ADDENDUM NUMBER: ONE (1)

DATE: May 2, 2024

PROJECT: ATHLETIC COMPLEX AT STOKES FIELD
COMMUNITY CENTER RENOVATION

DESIGNER: MONTGOMERY COUNTY ENGINEERING

2
A1.4 BUILDING SECTION
BUILDING 1 SCALE 1/4"=1'-0"

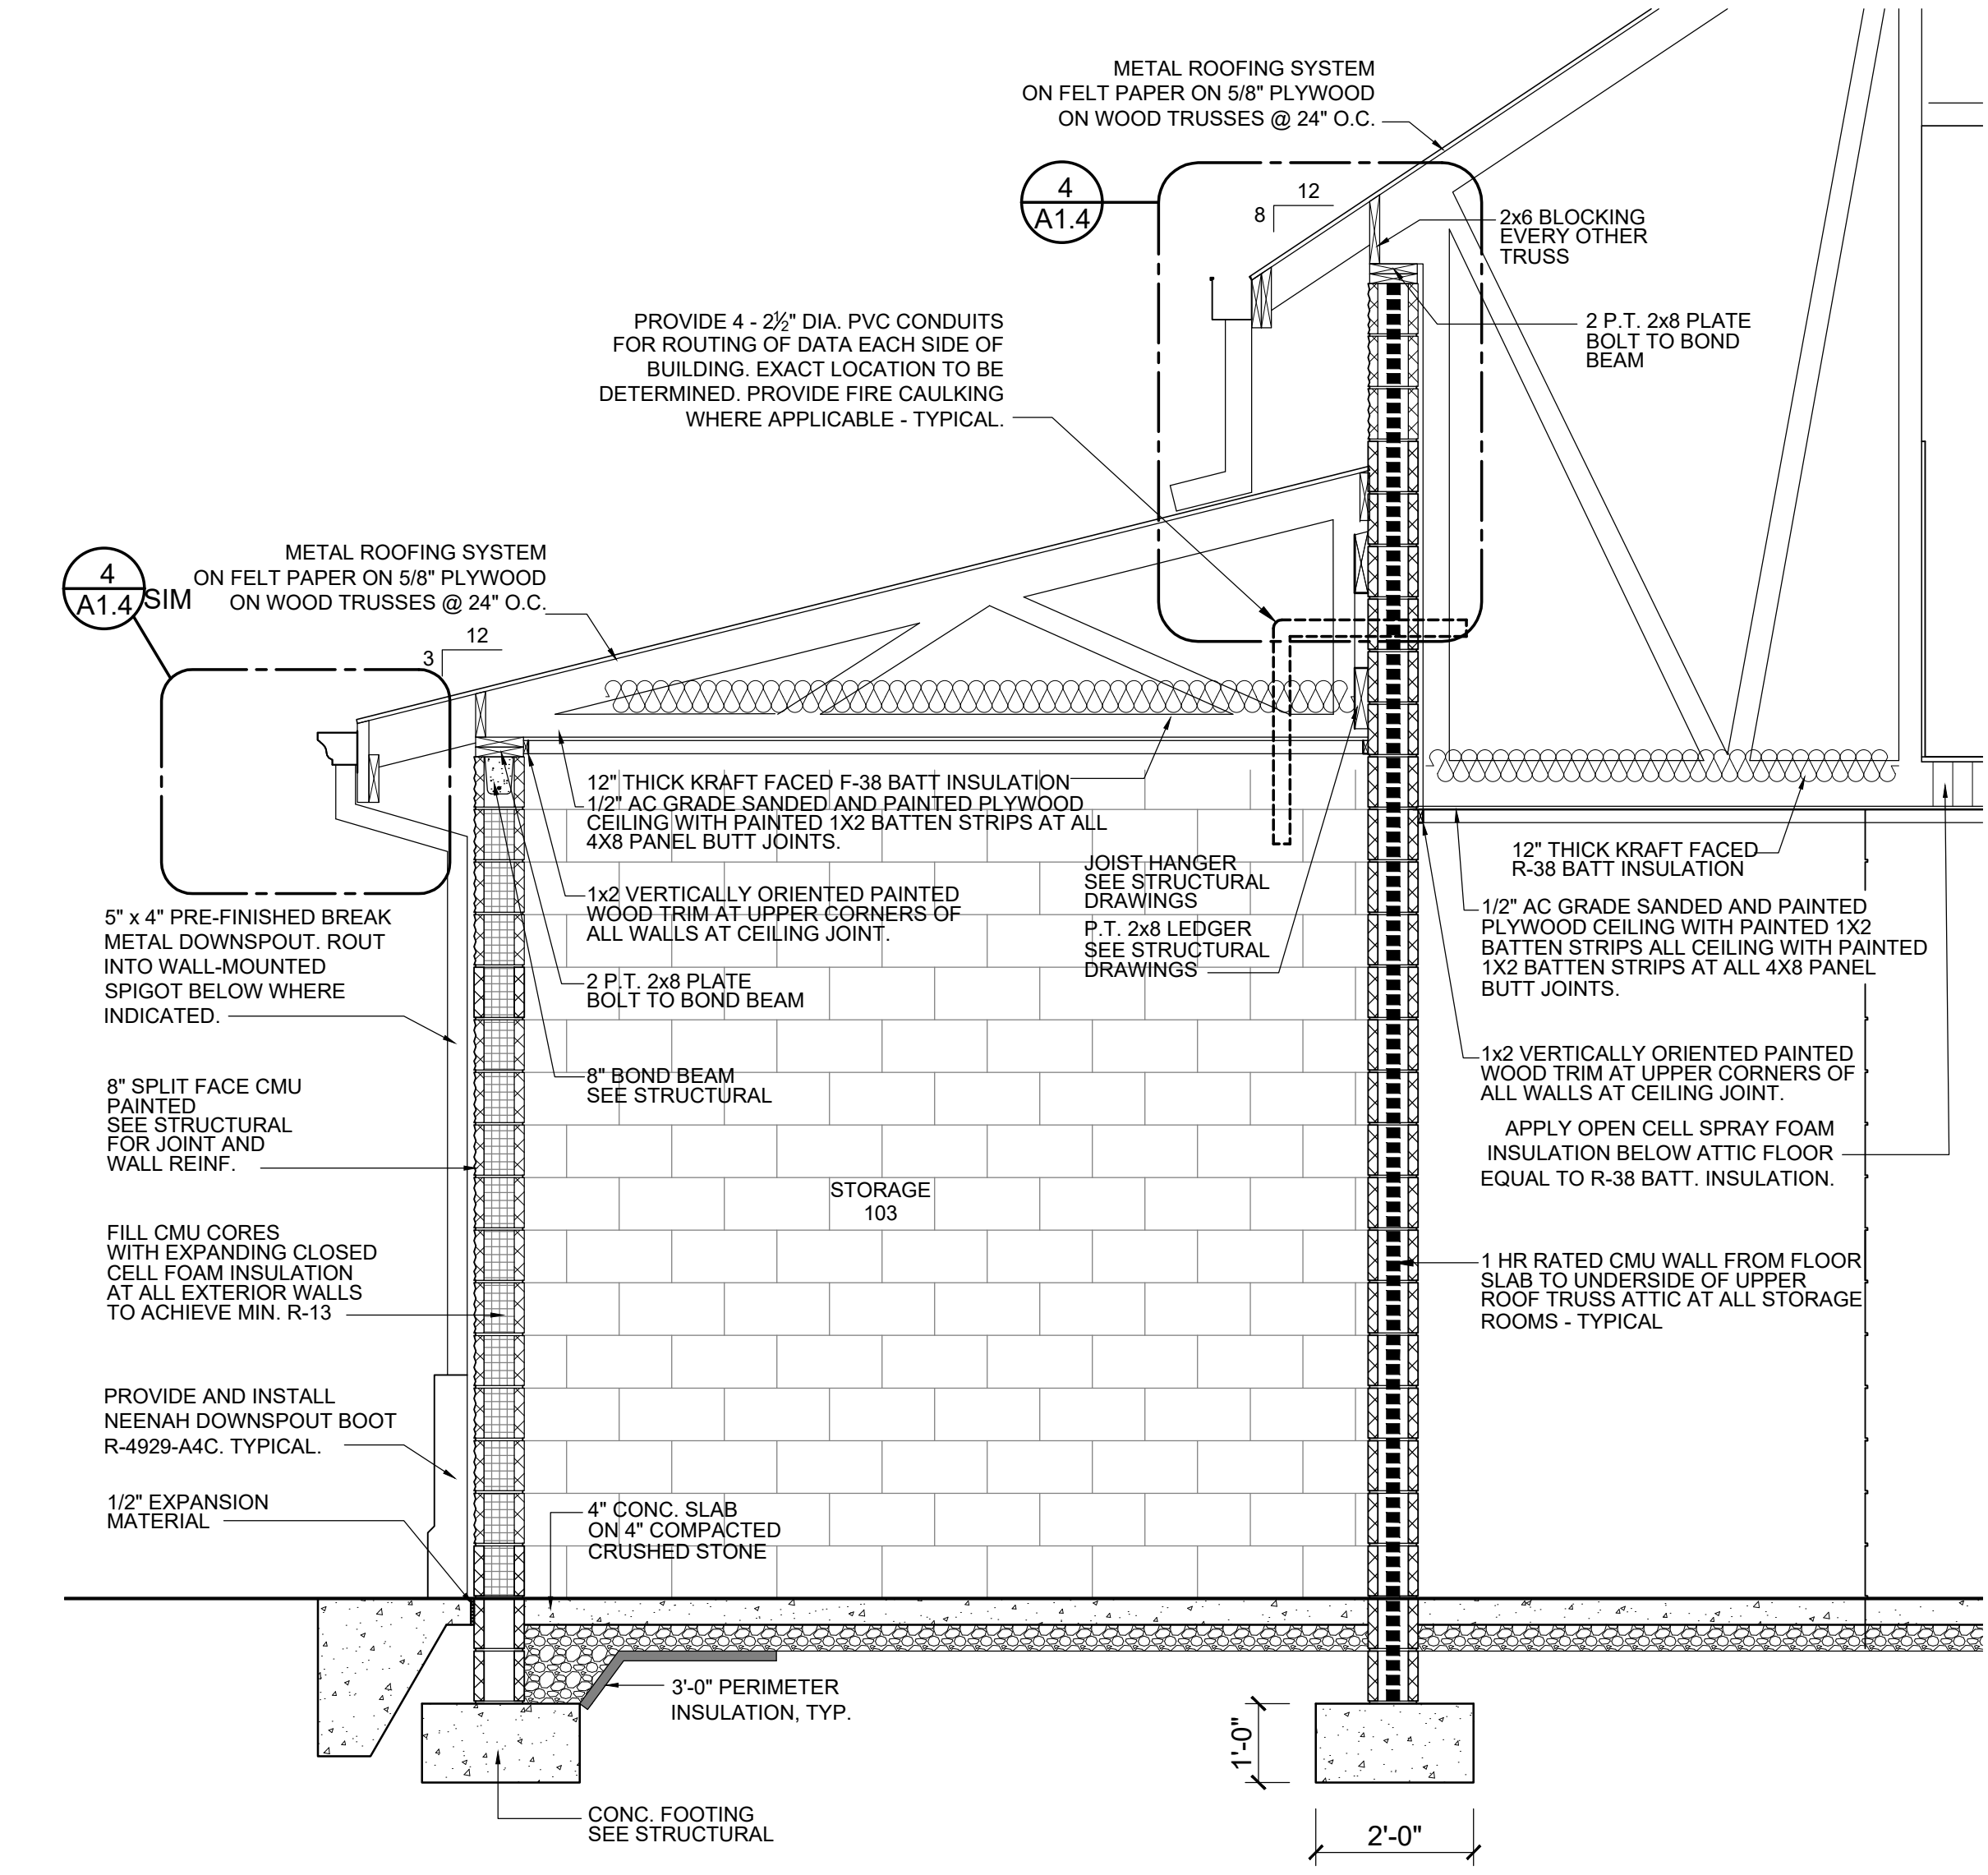
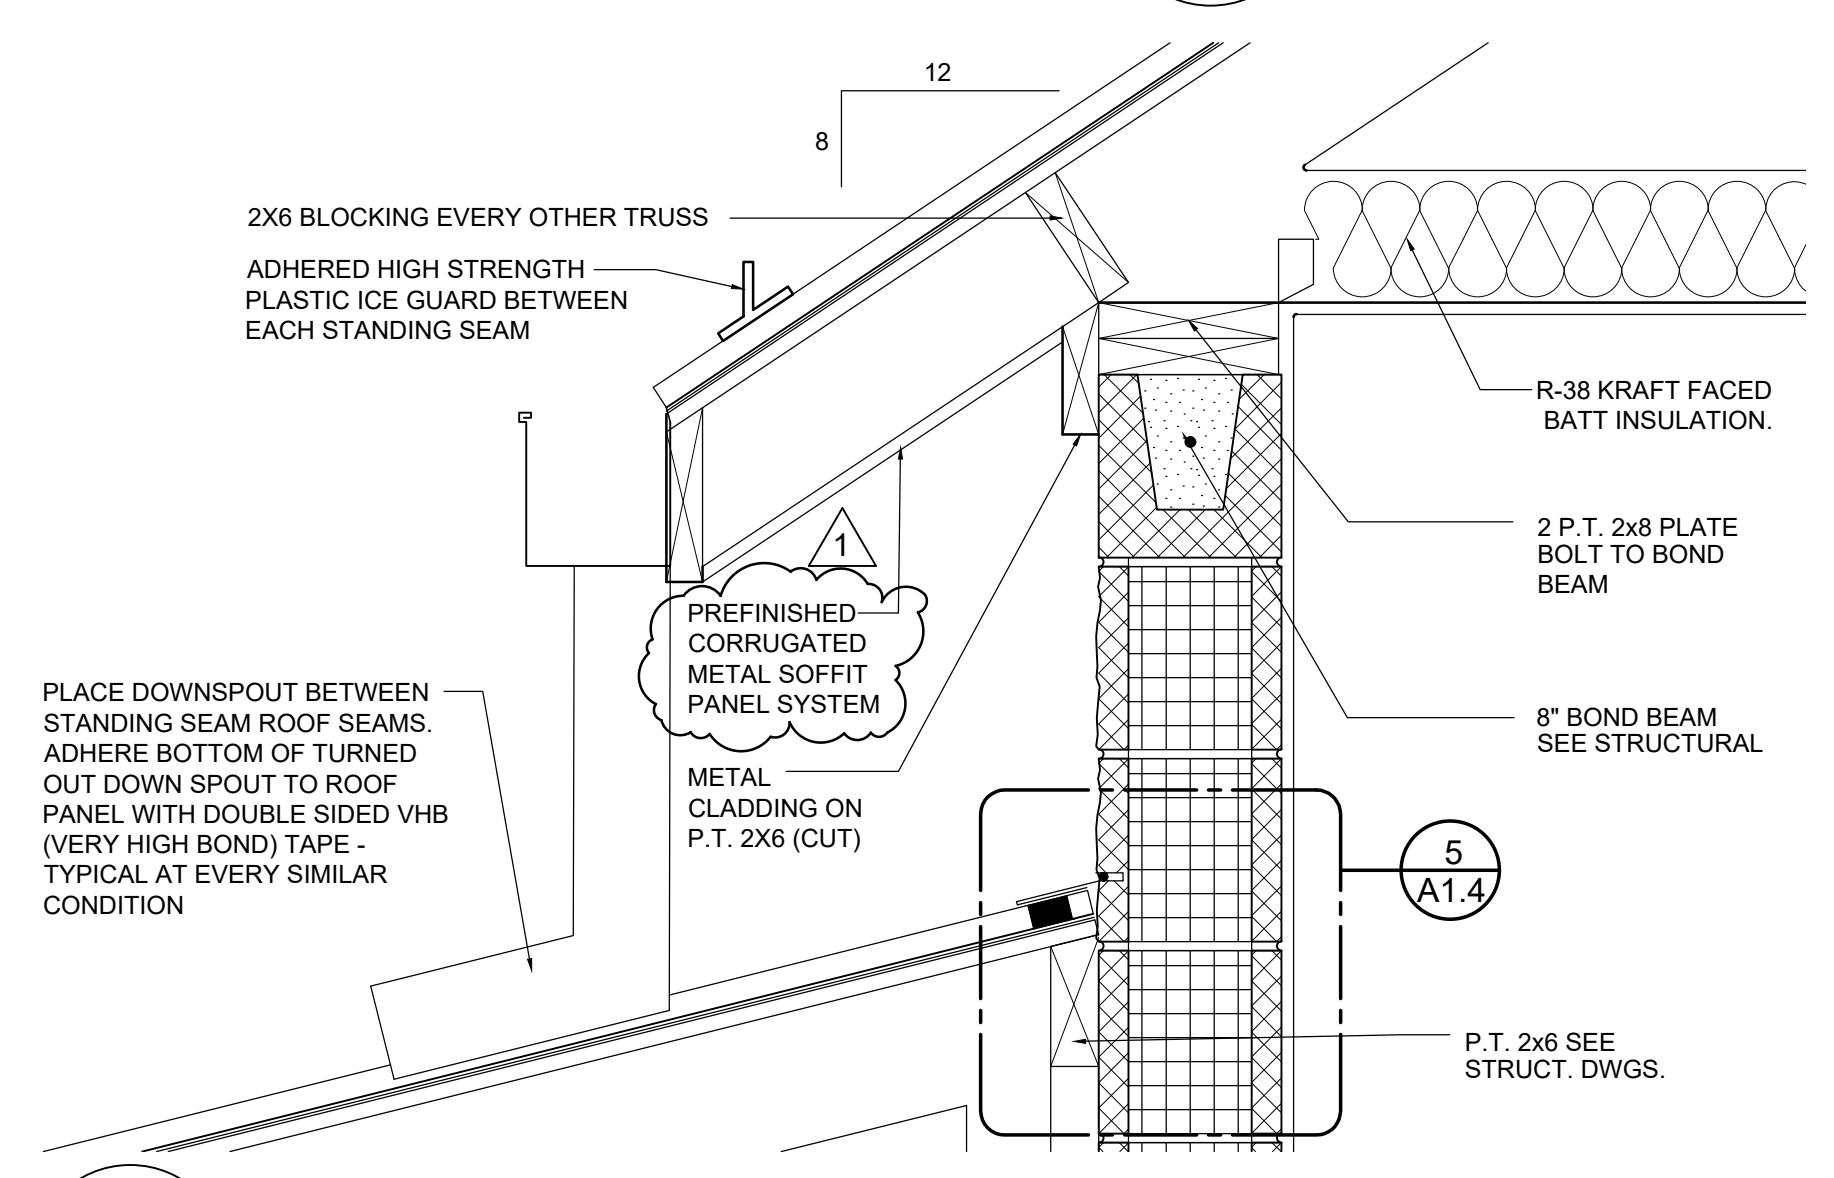
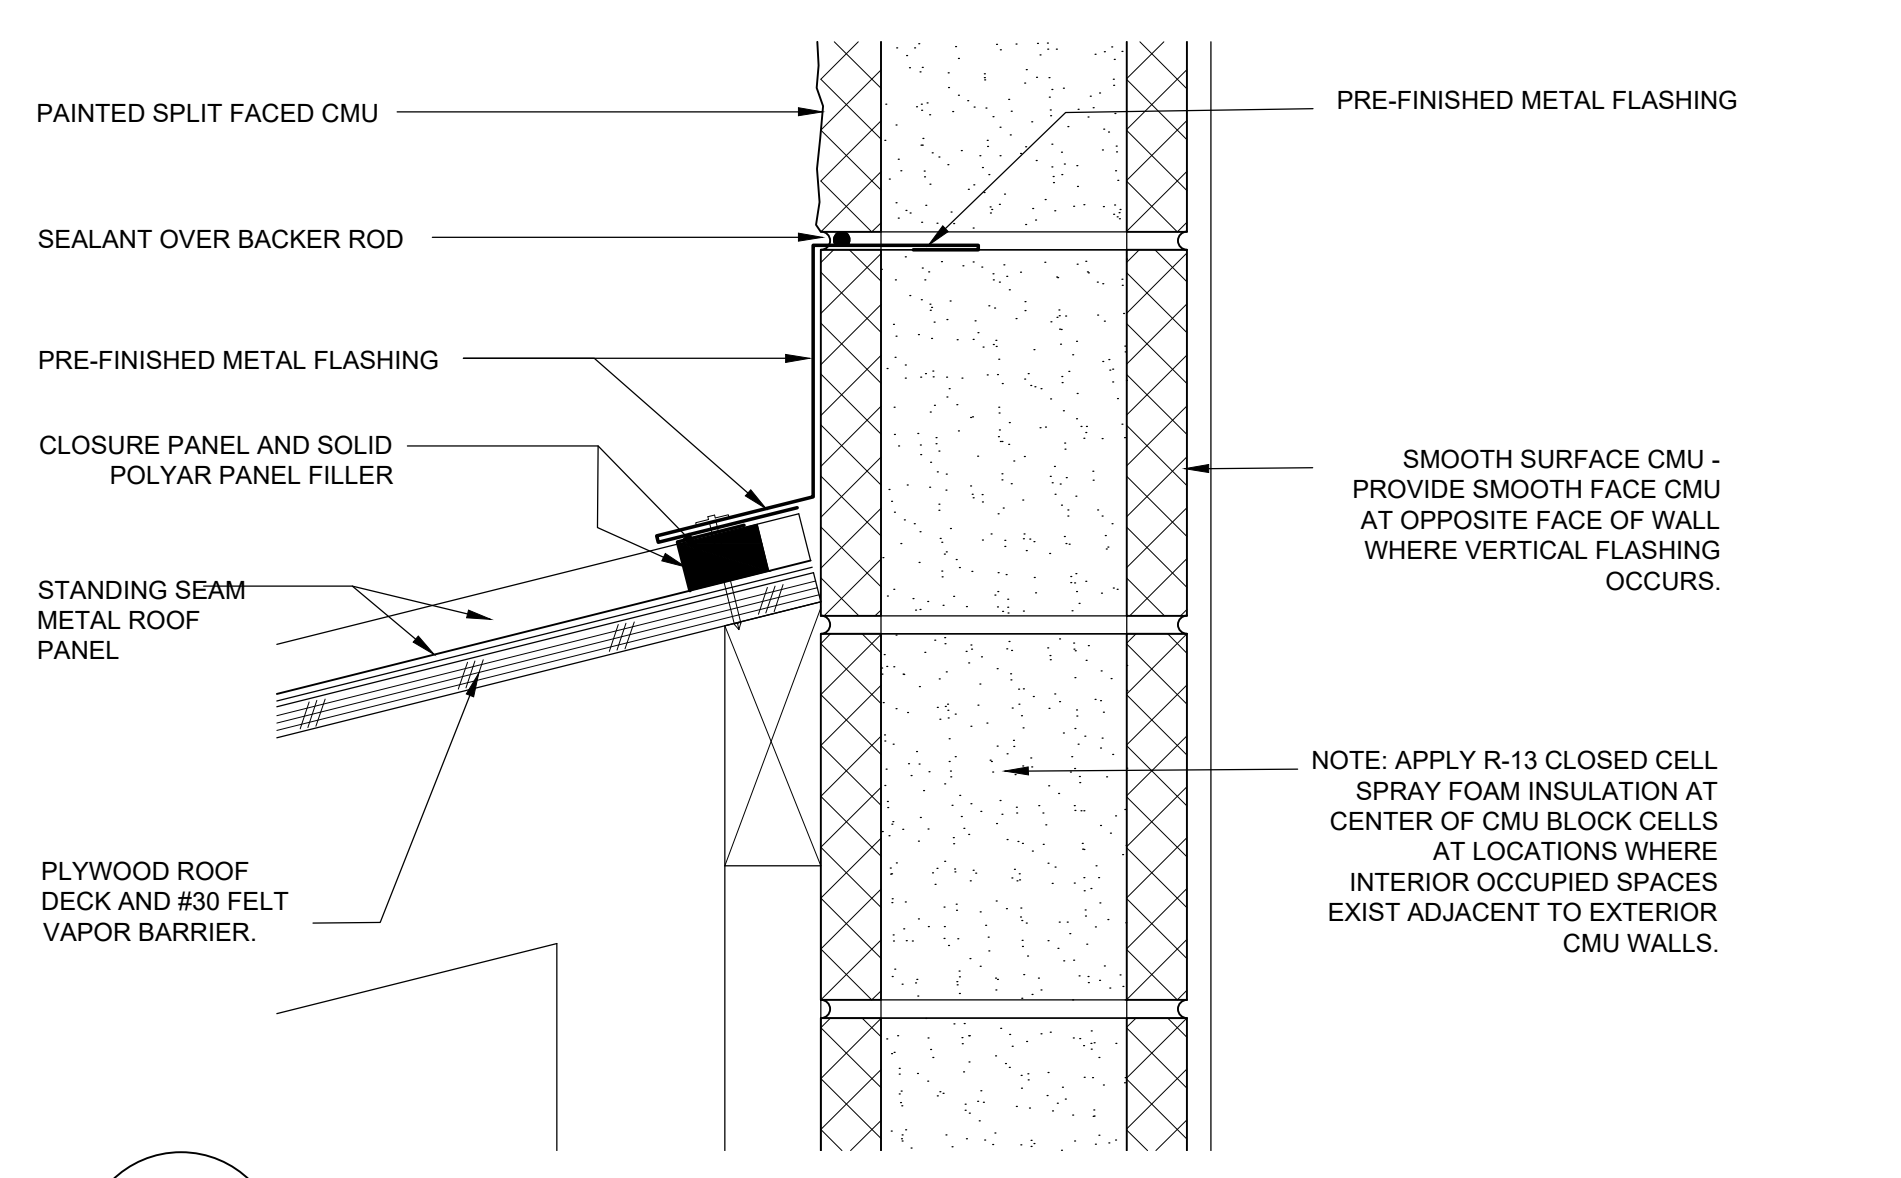
3. Drawing Sheet A1.4: Drawing A1.4 is revised and dated 4-30-2024 and replaces the original A1.4. Notes to a section detail calling out the soffit material has been revised to call out Pre-finished Corrugated Metal Soffit Material.

- Q.** Does metal ceiling of cooking pavilion attach to wood 2x10 purlins?
A. See revised sheet A1.4 and specification section 074110 for new details.
- Q.** Plan A3.0 Detail 1 shows spigot in Northeast corner of building, note says see plumbing drawing but there is no plumbing drawing for this building.?
